U.S. Nuclear Regulatory Commission
LIC-96-0010

ATTACHMENT B

DISCUSSION, JUSTIFICATION AND NO SIGNIFICANT HAZARDS CONSIDERATION

The Omaha Public Power District (OPPD) proposes to revise the Fort Calhoun Station (FCS) Unit No. 1 Technical Specifications (TS) to allow storage of unirradiated fuel in Region 1 of the Spent Fuel Pool (SFP) up to a 4.5 weight percent (w/o) Uranium-235 (U^{235}) enrichment. The balance of the SFP, denoted as Region 2, will have a prescribed enrichment/burnup restriction. TS 2.8(10), which currently contains this limit on initial enrichment is being deleted, and the proposed limit for fuel enrichment storage requirements will be relocated to the Design Features TS 4.4. TS 2.8(12) is being revised to increase the boron concentration required to be maintained in the SFP whenever unirradiated fuel is in the SFP.

FIGURE 2-10

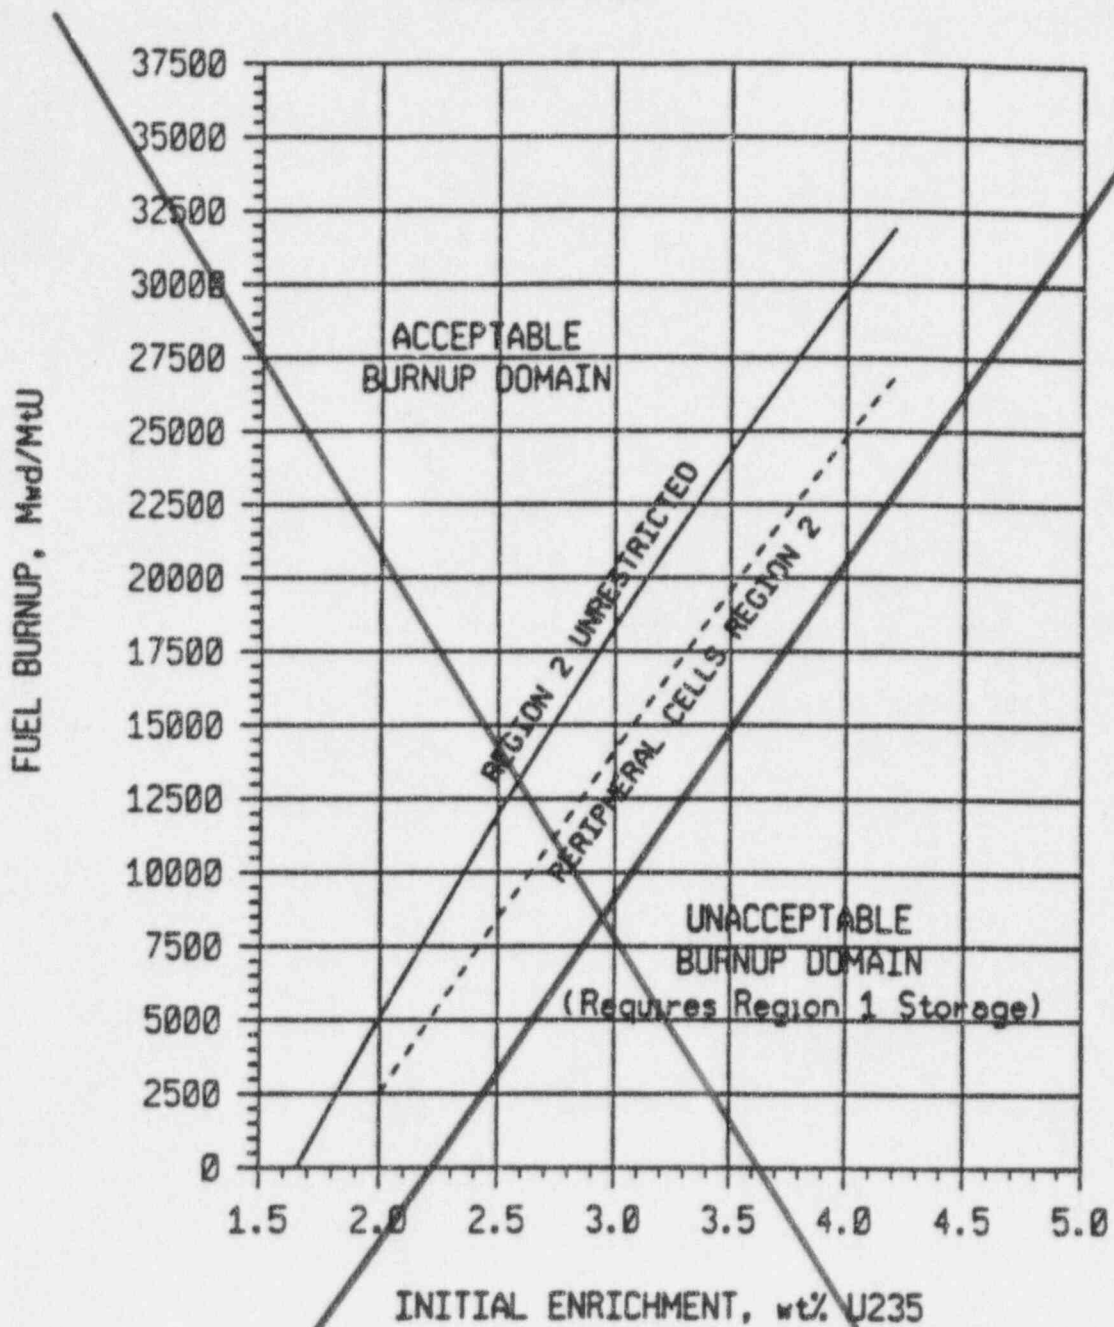
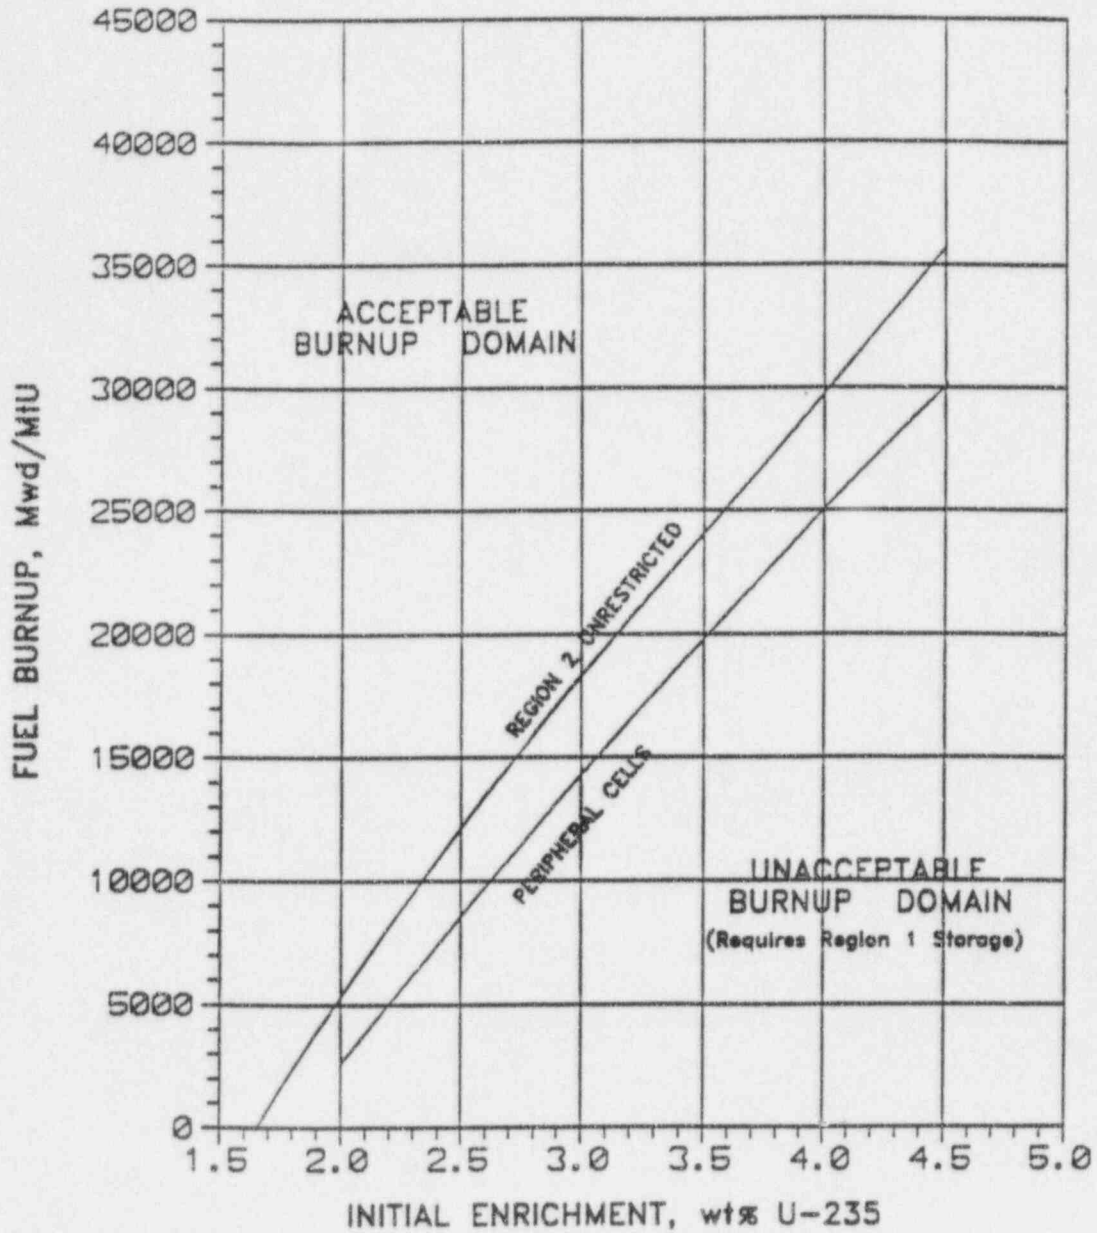
- (11) Storage in Region 2 of the spent fuel racks shall be restricted to those assemblies whose parameters fall within the "acceptable" area of Figure 2-10. Storage in the peripheral cells of Region 2 shall be restricted to those assemblies whose parameters fall within the noted area of Figure 2-10.

A spent fuel assembly may be transferred directly from the reactor core to the spent fuel pool Region 2 provided the independent verification of assembly burnups has been completed and the assembly burnup meets the acceptance criteria identified in Technical Specification Figure 2-10.

The proposed changes to the TS would increase the allowable fuel enrichment from 4.2 w/o to 4.5 w/o U^{235} in Region 1 of the SFP and modify the burnup/enrichment restrictions imposed on fuel stored in Region 2 to include fuel with an enrichment up to 4.5 w/o.

- NOTES:
1. Any fuel assembly ($\leq 4.5\%$ average U-235 enrichment) mechanically coupled with a full length CEA may be located anywhere in Region 2.
 2. Peripheral cells are those adjacent to the Spent Fuel Pool wall or the cask laydown area.
